## Design Review Subcommittee (DRSC)

**SUBJECT:** **Discretionary Sign Permit 13-243, SC Professional Plaza Monument Sign**, a request to consider a new monument sign on an existing commercial/office buildings located at 653 Camino De Los Mares.

**D/F MONUMENT SIGN - \*EXTERNALLY ILLUMINATED**  
SCALE 1/2"= 1'- 0"

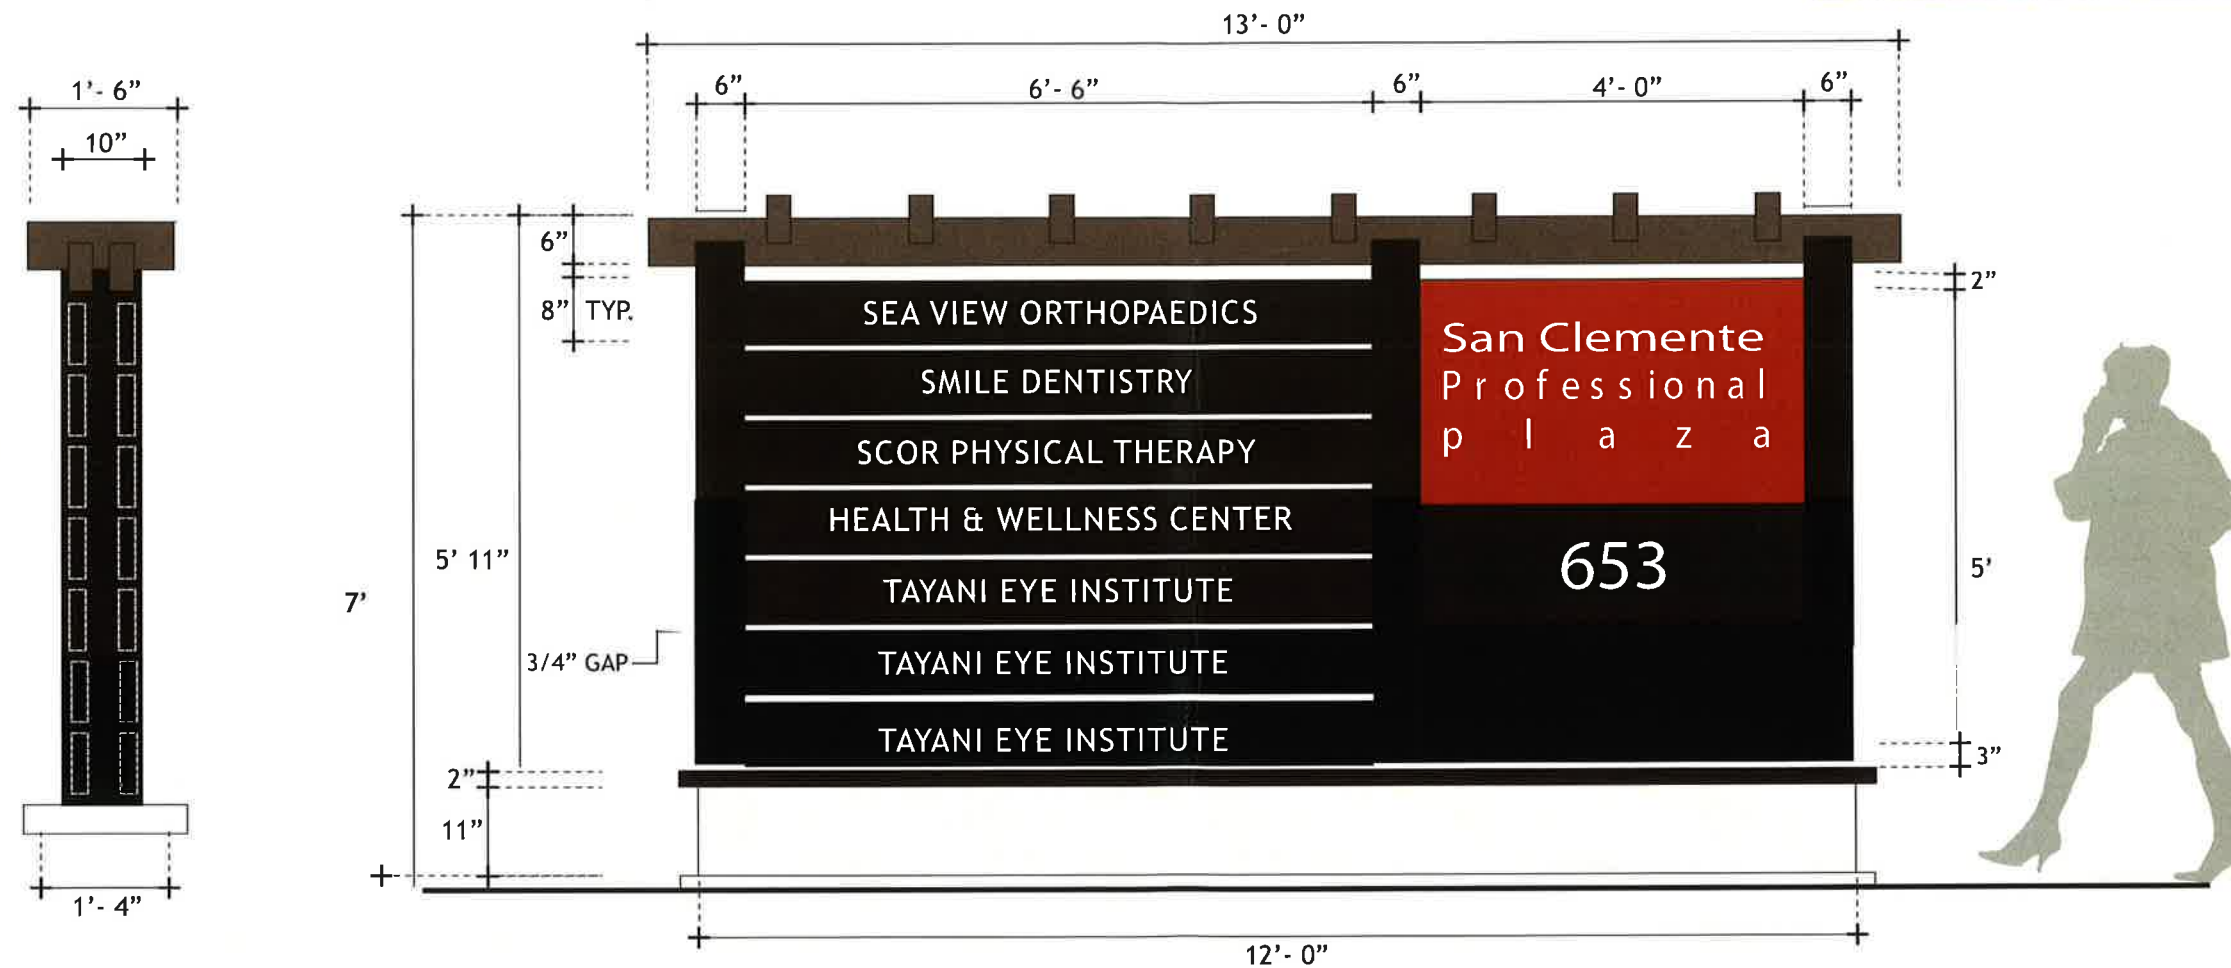
Staff's position is that external illumination is an improvement from the internal illumination previously proposed. Additionally, the trellis element at the top is an excellent way to bring a character defining feature from the Spanish building into the design. Staff has concerns about the use of the black color for the primary portion of the signage and the use of aluminum for the certain parts of the sign, especially for the top trellis portion.

**Sign Panel Frame Color** – Instead of the black sign frame color, staff recommends utilizing a dark brown color.

**Wood Trellis Color and Material** – The trellis color should match the color of the wood trellis of the building. The material should be wood, or similar faux material. Aluminum is not appropriate.

**Stucco Columns** – Stucco columns should be added to the sides have the same color and stucco finish as the building.

**Exterior Illumination** – Exterior illumination should still be utilized.
